**Item 3.****Development Application: 28-36 Bayswater Road, Potts Point - D/2023/71**

File No.: D/2023/71

**Proposal Summary:** The subject application seeks consent for a 'shop top housing' development, incorporating 22 residential units above 4 sub ground, lower ground and ground level commercial tenancies, and includes demolition of existing structures, excavation for 2 new basement levels, substantial alterations and additions to 4 existing terraces, and construction of a new building.

Figure 26: Roof plan

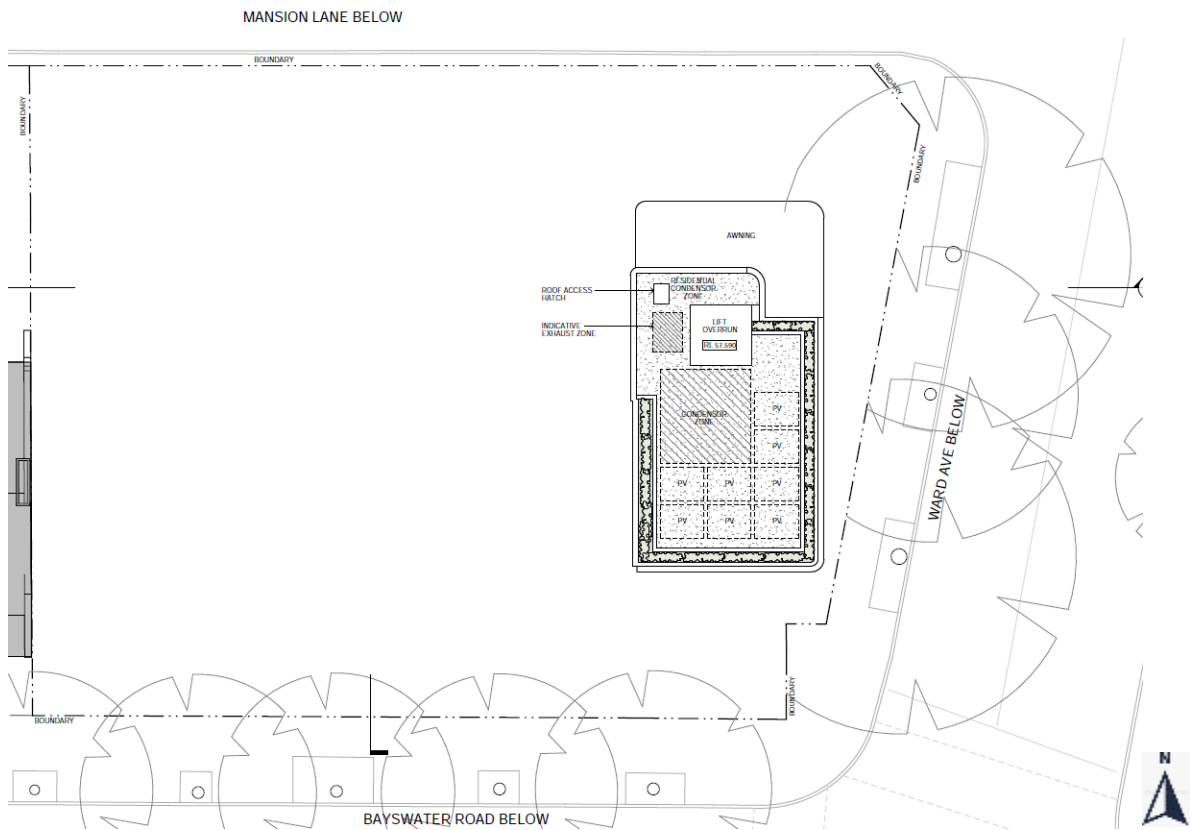
- submission of an amended landscape proposal which includes:
    - provision of a bio-solar roof (i.e. green roof integrated with solar panels) to the roof level of 36 Bayswater Road (drawing DA-105)

- reduction of the size of the rooftop awning (drawing DA-105) to accommodate additional tree planting within the planter box located to the north of the Level 4 fire stairs

Figure 35: Height plane diagram - existing development

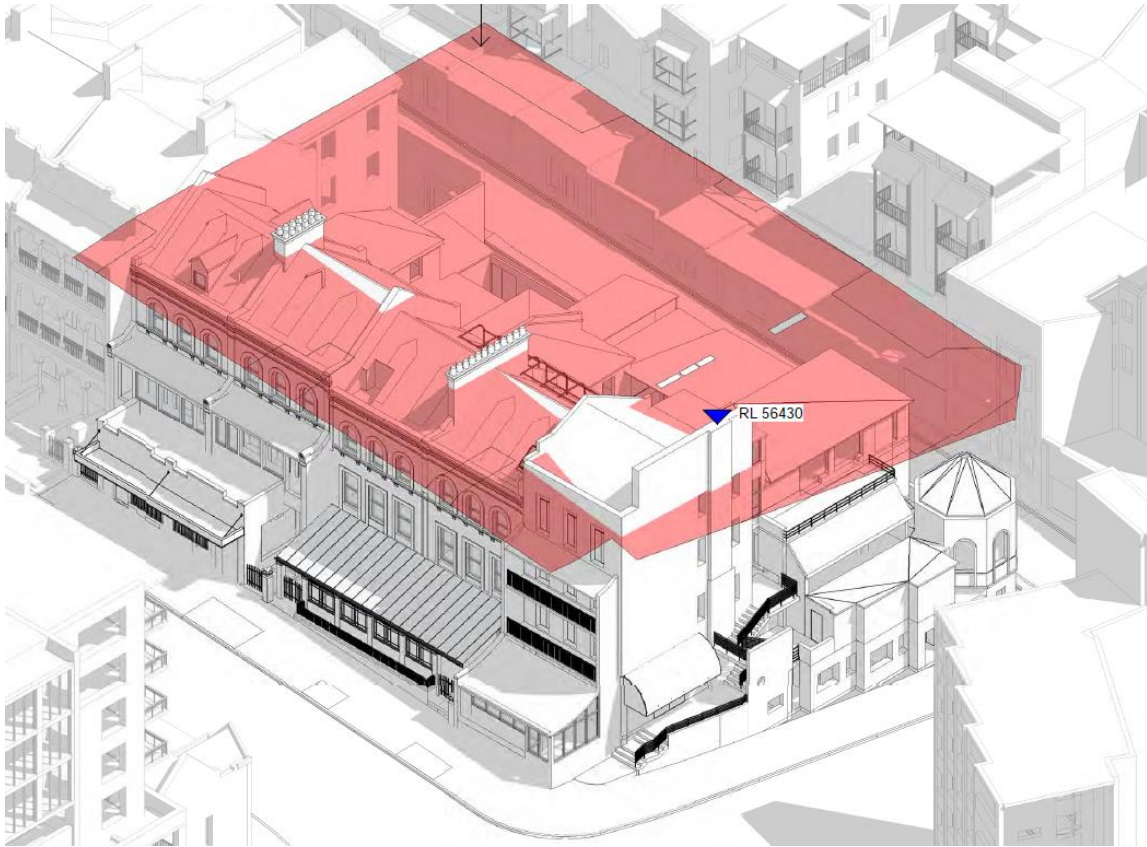
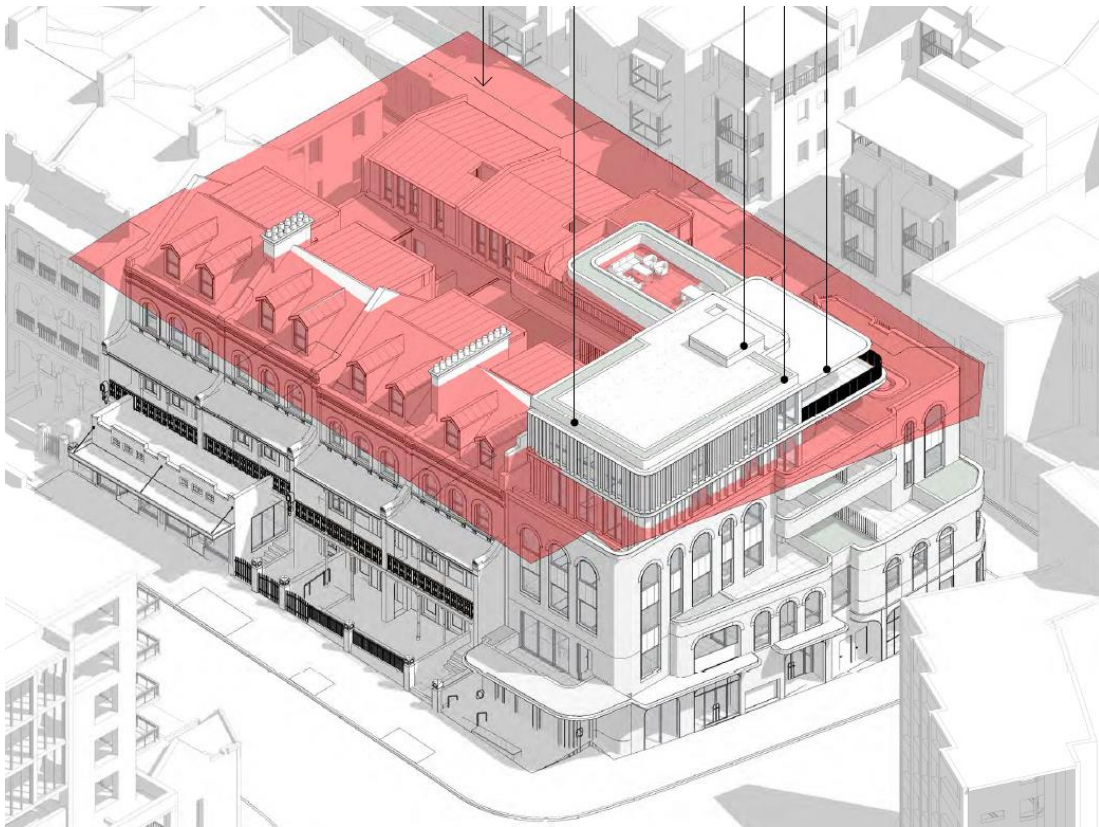
75. The elements of the existing and proposed building which exceed the height standard are shown in Figure 35 to Figure 37.

Figure 44: Site analysis plan showing the height of surrounding buildings

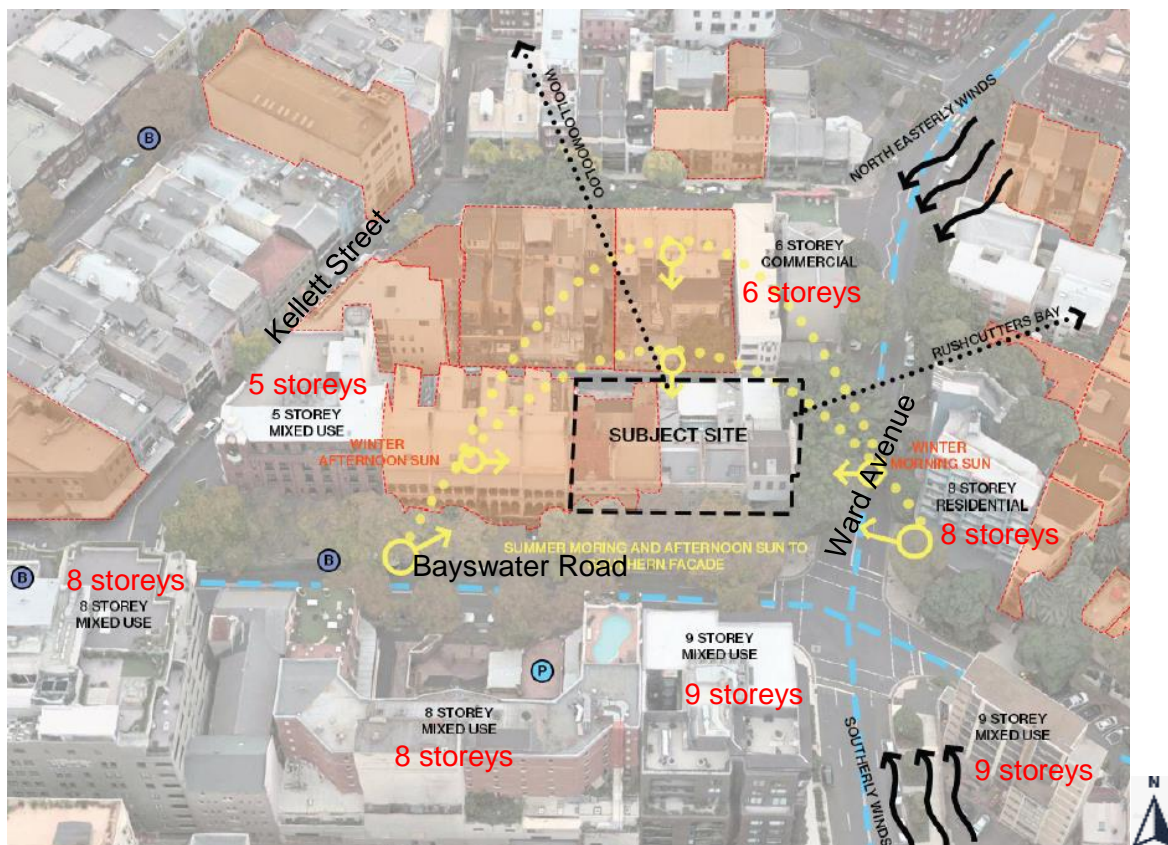
- (f) The taller mass at the corner of Bayswater Road and Ward Avenue aligns with the taller buildings on the remaining 3 corners of the intersection, including the 8-storey building on the north-east corner (40 Bayswater Road), the 9-storey building on the south-east corner (51-57 Bayswater Road) and the 9-storey building on the south-west corner (37 Bayswater Road). See Figure 44.

Figure 53: Existing (left) and proposed (right) building footprint of new corner building

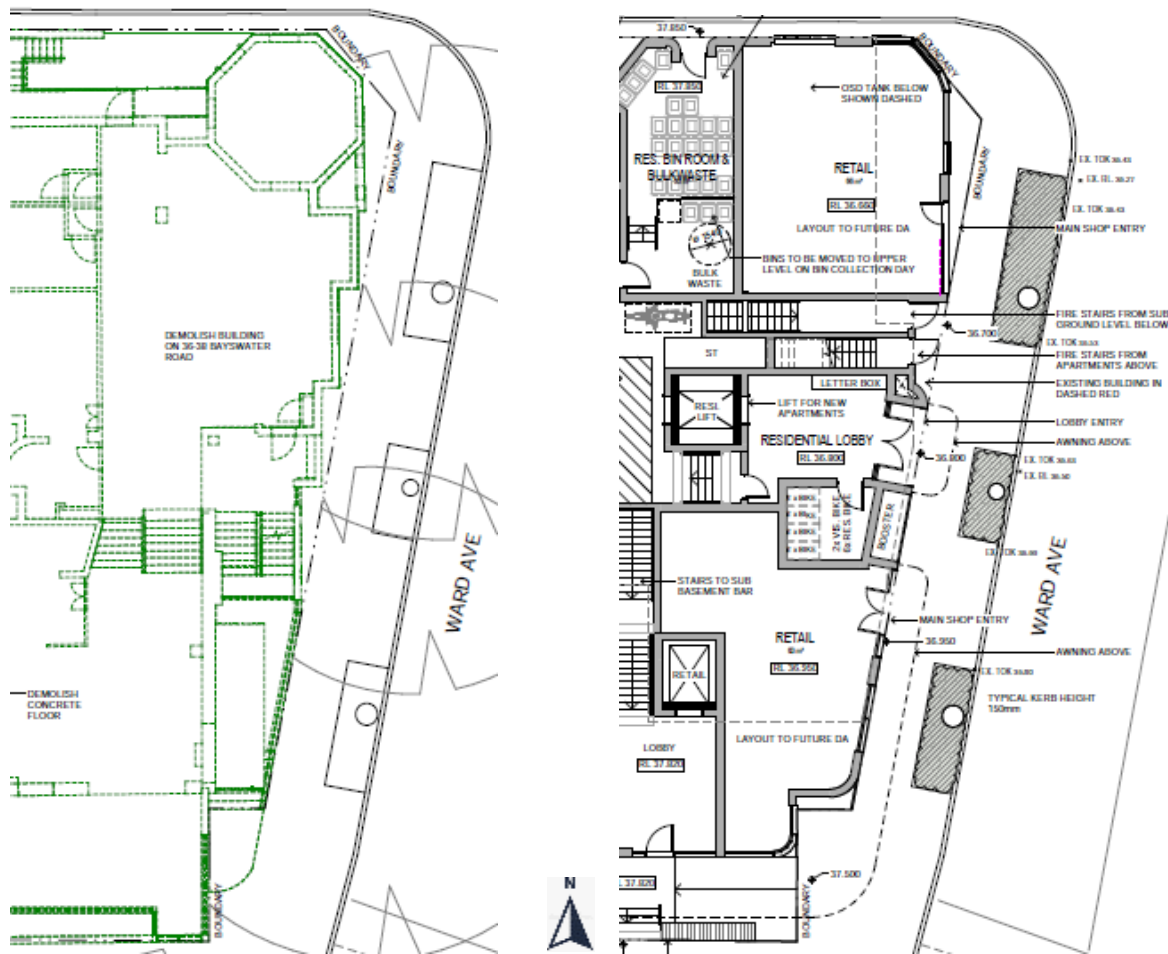
152. For any new works adjacent to the Ward Avenue frontage, which is located outside of the existing building footprint, a condition has been recommended requiring that the works be supported by a construction methodology incorporating a cantilevered design in these locations. This is to ensure that no new works (e.g. footings) will occur outside of the existing building footprint that will impact on the SRZ of the trees. Alternatively, where there are point encroachments outside of the existing building footprint (e.g. in the location of the proposed booster as shown in Figure 53) and a cantilevered design cannot be provided, the ground floor plan is to be adjusted to reflect the existing building footprint unless detailed root investigations are undertaken, and it can be demonstrated that there will be no impact to the significant street trees. Suitable conditions are recommended to address these issues.

Figure 54: Sun eye view of the Level 3 and 4 communal open space areas at 3pm in midwinter

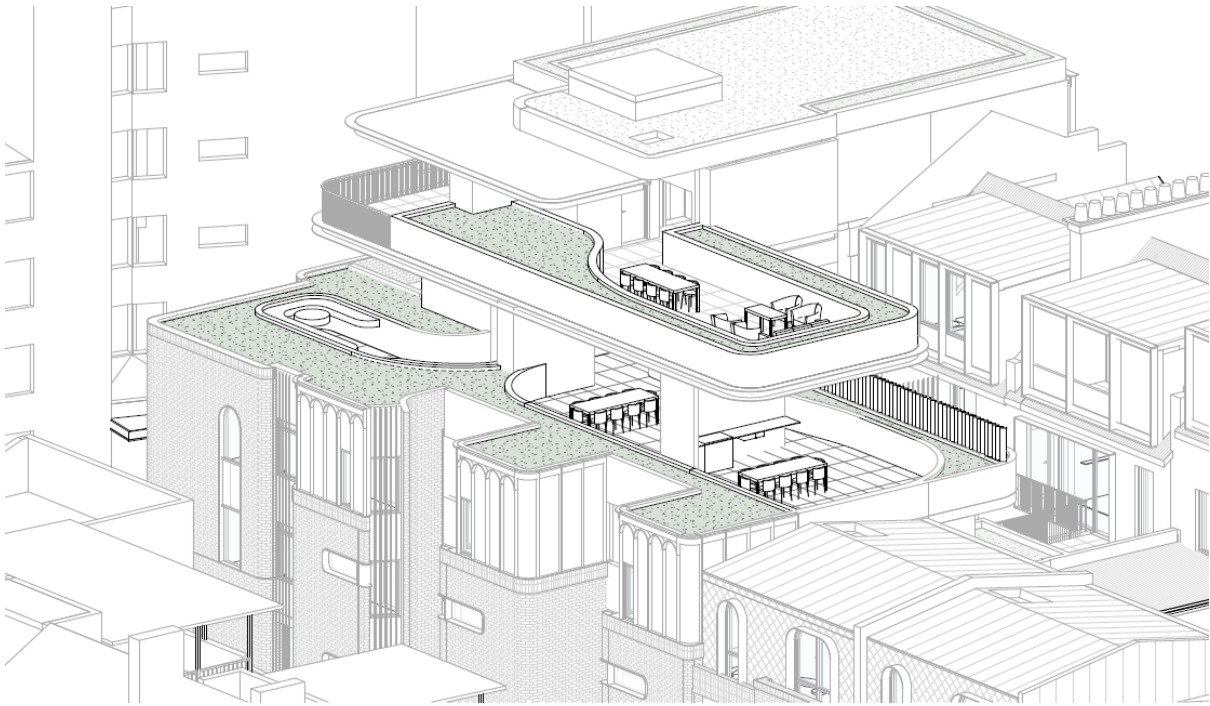
156. As shown in Figure 54, the rooftop COS areas have been located and designed to achieve good amenity in terms of solar access. The rooftop communal areas have a northerly aspect and exceed the minimum requirement that 50% of the principal usable part of the COS receives direct sunlight for a minimum of 2 hours between 9am and 3pm at midwinter. The upper levels and rooftop awning will also provide shade and shelter to the COS areas.

Figure 56: Section plan showing relationship between the proposed communal open space and the existing development on the northern side of Mansion Lane

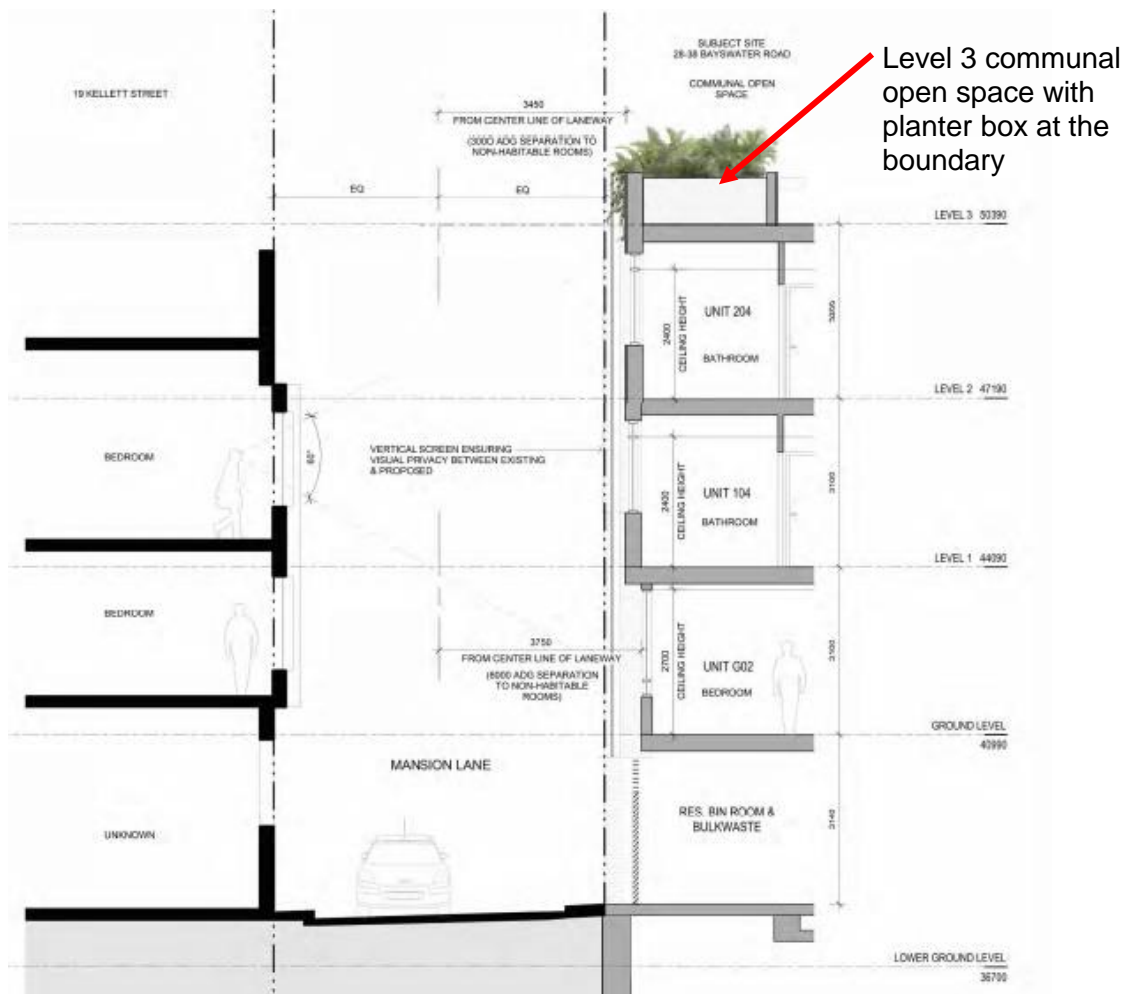
164. As shown in Figure 56 the proposed rooftop COS areas are also not at eye level with any of the existing developments on the northern side of Mansion Lane and therefore will not have a direct view line into the existing apartments.

Figure 58: Section plan showing proposed acoustic attenuation to the terraces

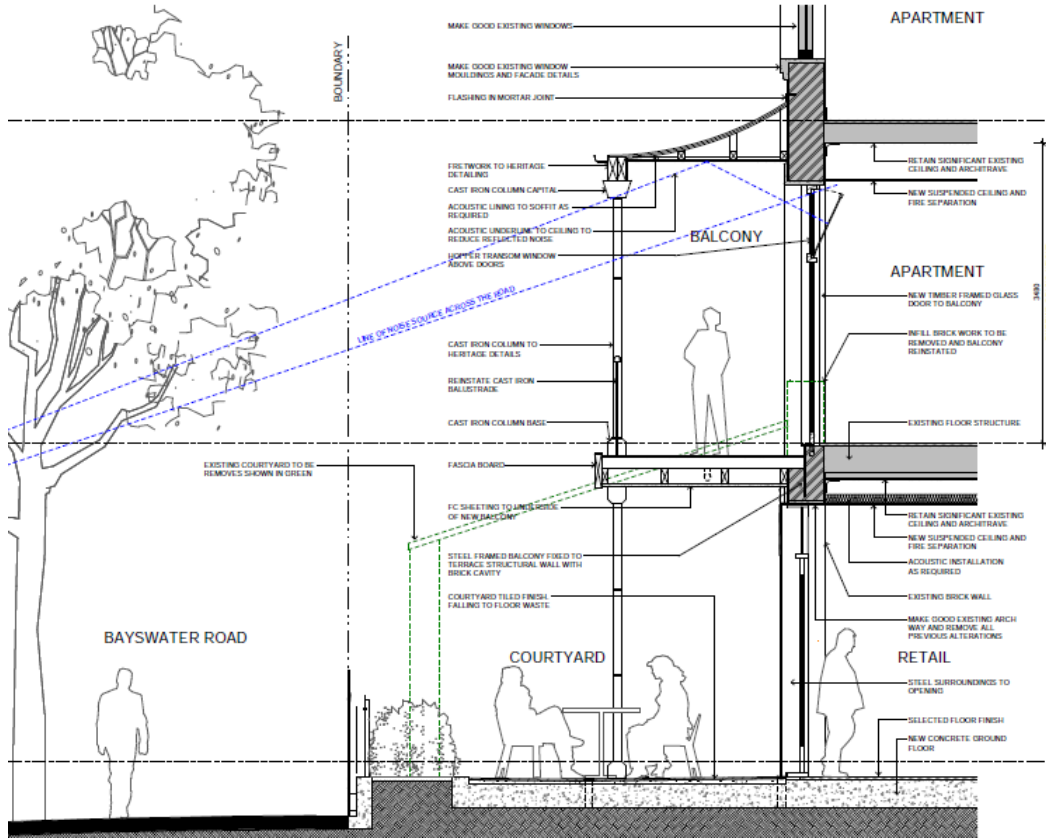
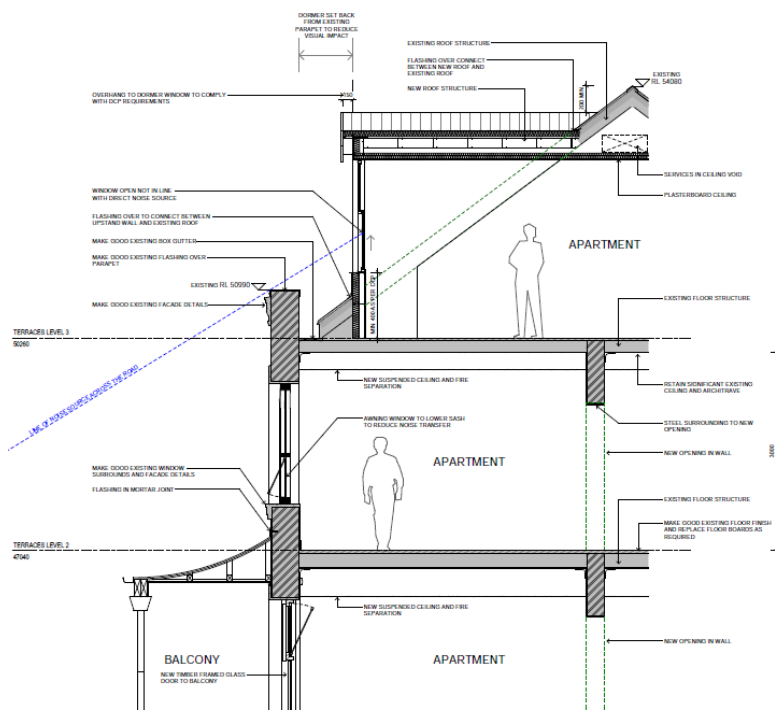
174. The acoustic assessment indicates that the Bayswater Road and Ward Avenue facades are noise affected. To ensure compliant internal noise levels are therefore achieved under natural ventilation conditions (i.e. when doors/windows are open), alternative solutions have been incorporated into the design. This includes the type of window selections (i.e. awning/hopper windows), the window orientation, and the provision of acoustic linings and screening (i.e. balcony soffit and parapets) to the south (Bayswater Road) and east (Ward Avenue) elevations. The open portion of the windows, relied on for natural ventilation, is equivalent to at least 5% of the floor area of the room (taking into account fly screens in the event they are provided) as required by the ADG. The plans have been amended to reflect the recommendations of the acoustic assessment as shown in Figure 58 and Figure 59.
